Appin Road Upgrade, Mount Gilead to Ambarvale

Addendum Review of Environmental Factors
Submissions Report

January 2024

Figure 3-6 Proposed location of rope fauna crossing

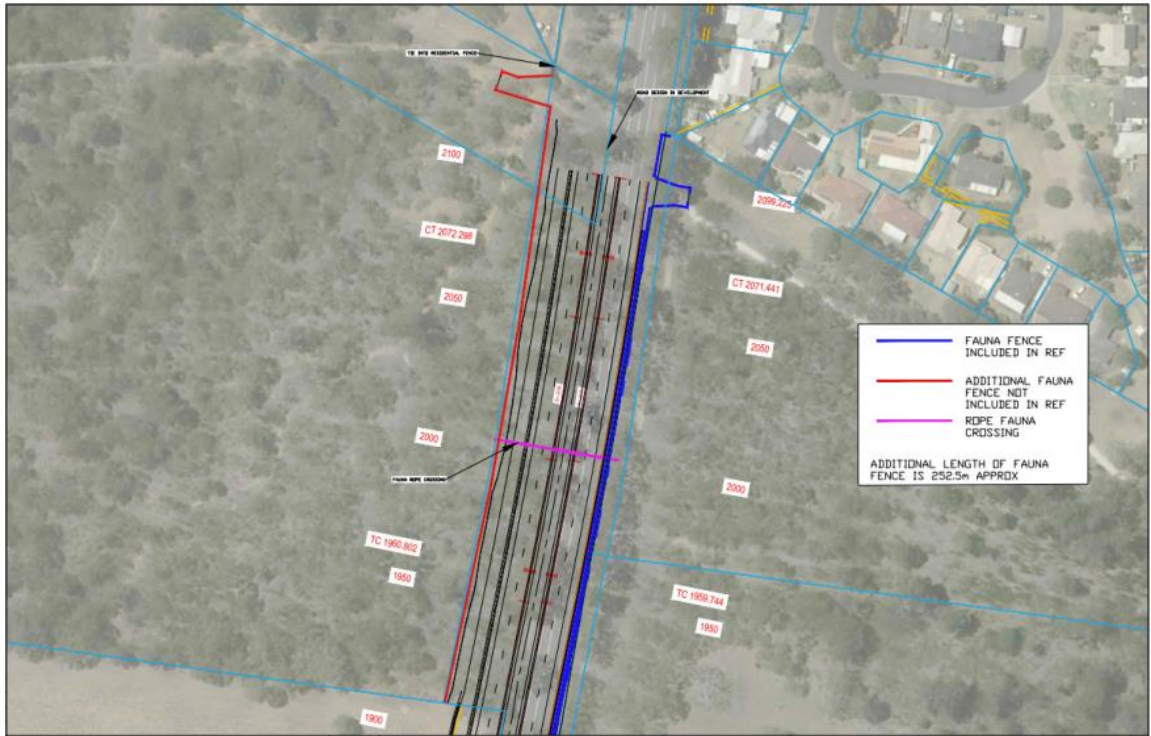
Figure 3-7 shows the koala exclusion fencing and rope fauna crossing located at Noorumba Reserve which was detailed in the REF Submission Report.¹² Figure 3-7 and Figure 3-8 provide examples of arboreal crossing structures similar to what will be implemented at Noorumba Reserve.

Figure 4-2 Glen Lorne Koala Underpass

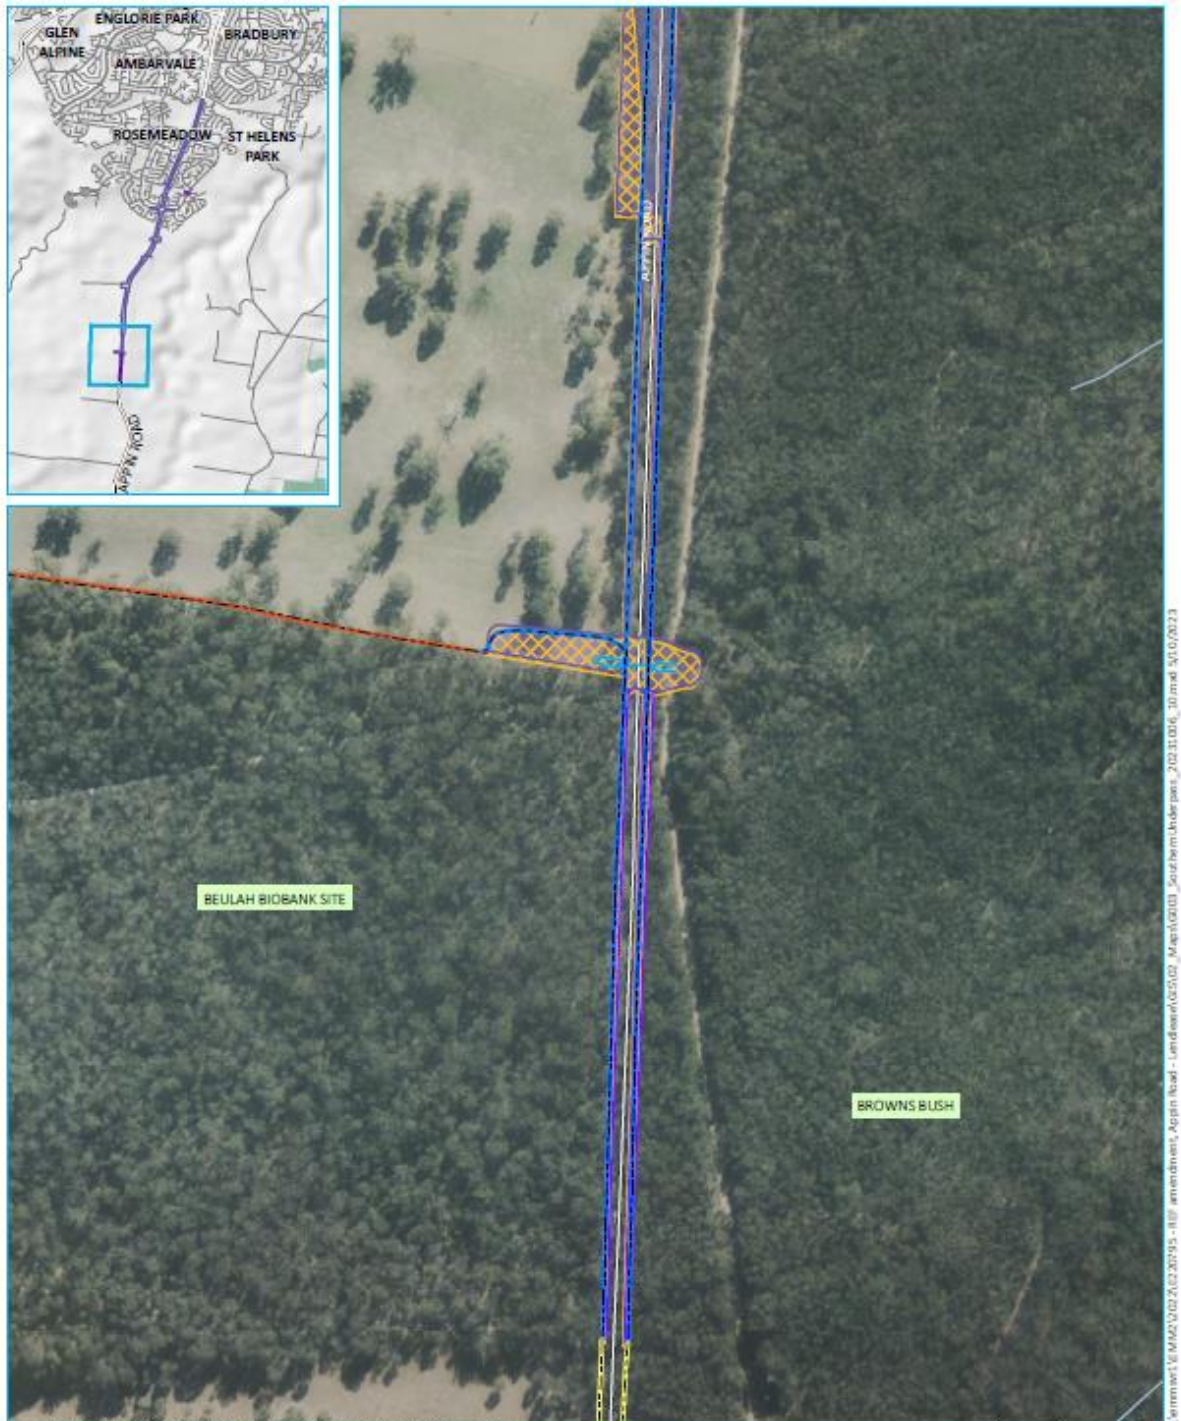
To address feedback around the efficacy of the proposed round concrete pipe underpass (2.4 metres in diameter and 57 metres in length), the underpass at Glen Lorne has been redesigned to incorporate a RCBC, with a height of 2.4 metres, width of three metres and a length of 53 metres. In addition, the underpass will have a flat concrete floor lined with a natural substrate, similar to that shown in Figure 4-1. Substantial redesign, particularly regarding existing and proposed services, has been undertaken to achieve this outcome. The underpass is now as large as feasibly possible taking account of engineering constraints including existing fibre optic cabling, sewer, high-voltage overhead powerlines and construction constraints of the site, including inability for significant road closures and impacts on the Noorumba Biobank site.

The length of underpass has been reduced by four metres, to 53 metres in length and the location of the underpass has been slightly modified to encourage koala use, whilst remaining on Lendlease land, and is now perpendicular to Appin Road to encourage access by koalas (refer to Figure 4-2). It is noted that Dr Stephen Phillips suggests that the Glen Lorne underpass should be replaced with a dedicated fauna overpass (bebo arch) or 3 metre by 3 metre RCBC that is centrally located within Noorumba biobank site. Further discussion on why this recommendation is not considered feasible is provided in Section 3.4.2.

Figure 4-14 Amended REF boundary.

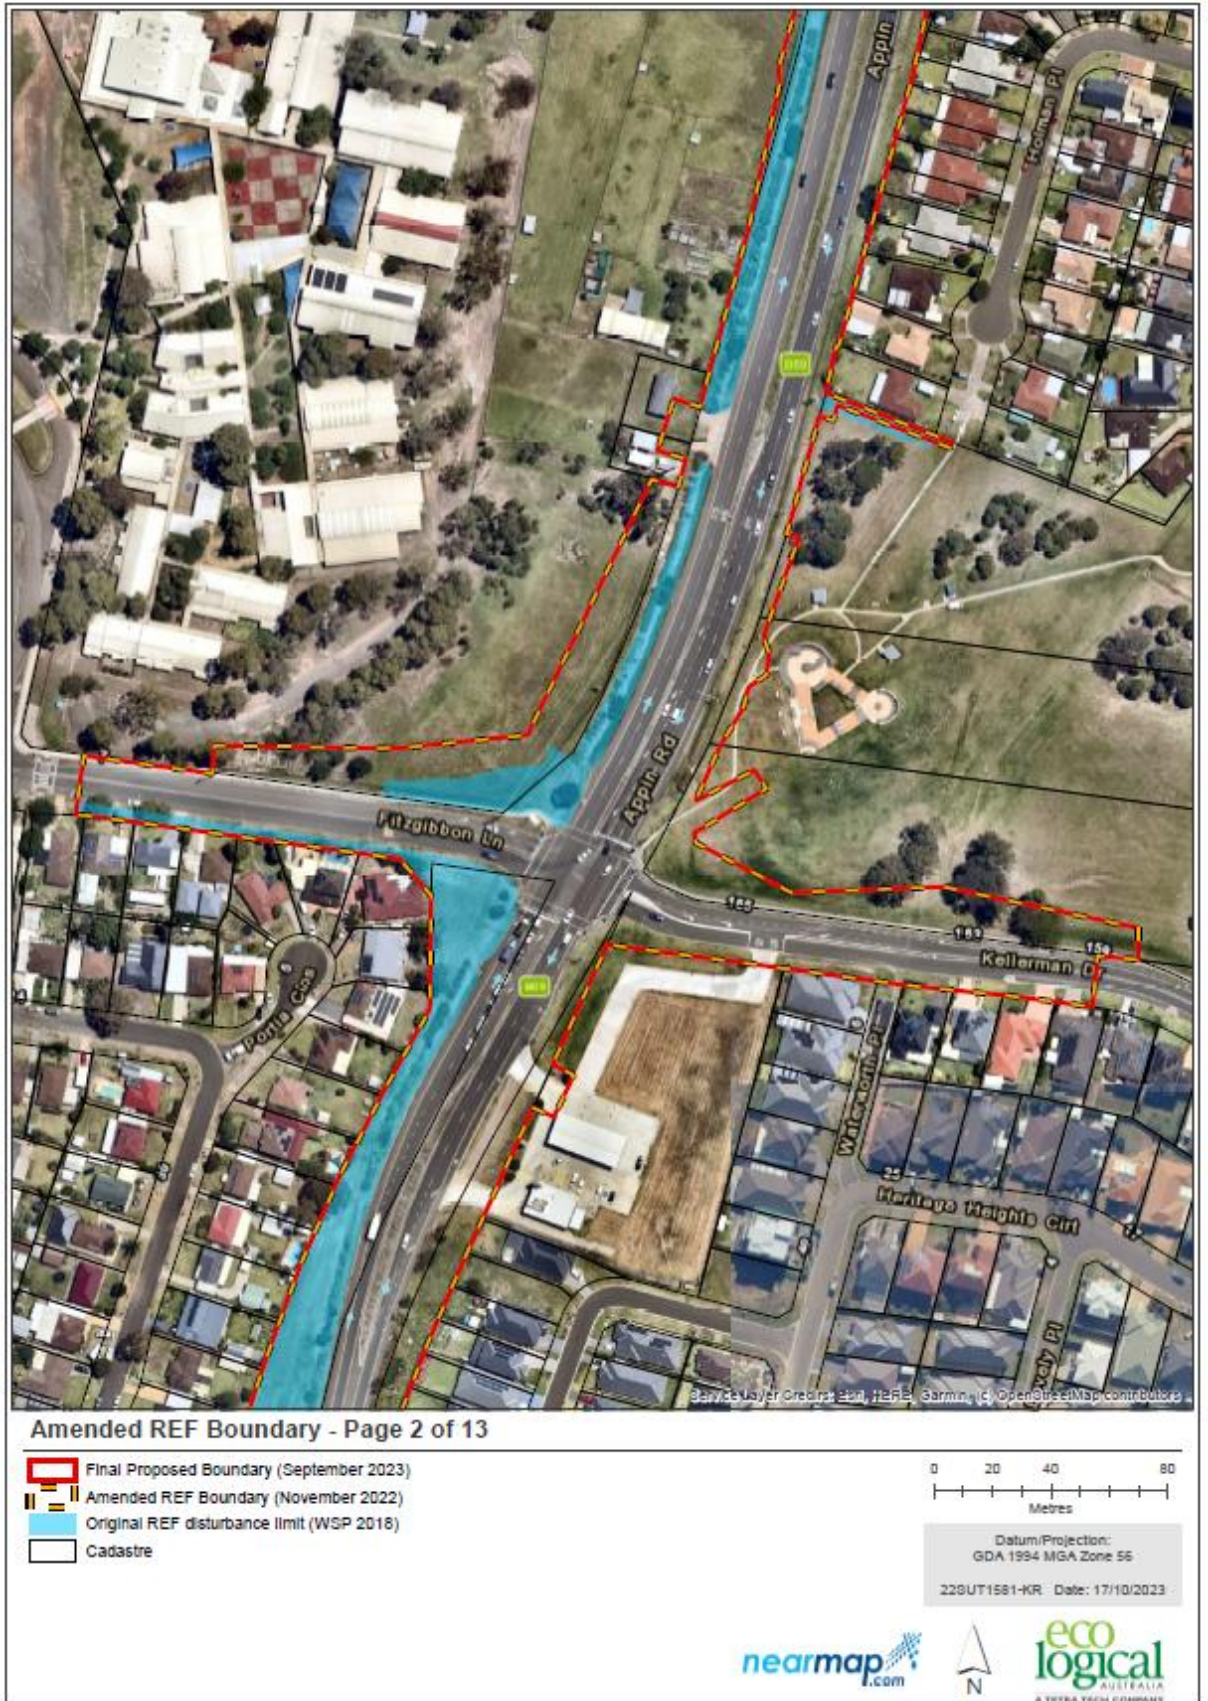
The project boundary as shown in the AREF requires some minor adjustments to accommodate the construction of the redesigned koala underpasses and other design refinements (Refer to [Figure 4-6](#)). The additional areas are around 4 ha and have been assessed in Chapter 5 of this Submission Report.
